Title 11 **DEPARTMENT OF TRANSPORTATION** **Subtitle 19 MOTOR VEHICLE ADMINISTRATION — SCHOOL** **VEHICLES**

11.19.02 Type I School Vehicles — Construction Standards

Notice of Proposed Action

The Administrator of the Motor Vehicle Administration proposes to amend Regulations **.20** and **.32** under **COMAR 11.19.02 Type I School Vehicles — Construction Standards**.

FIGURE 1

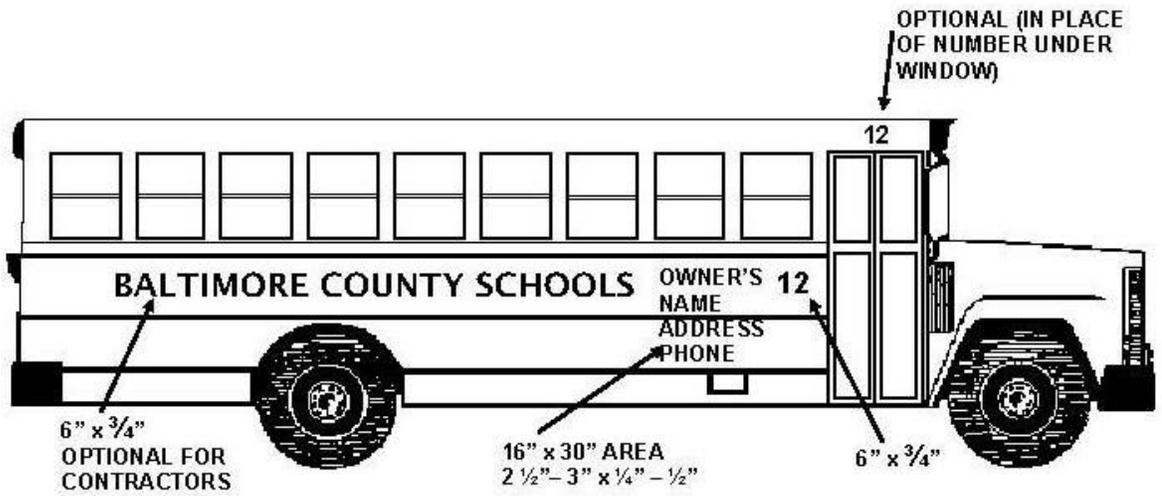
The purpose of this action is to update measurements for the required size of lettering on a school bus in the figures illustrated within the regulations. In addition, this action clarifies when a door may not be placed to the left of the driver

Existing Figures 1 — 3 are being proposed for repeal.

New Figures 1 — 3 appear below.
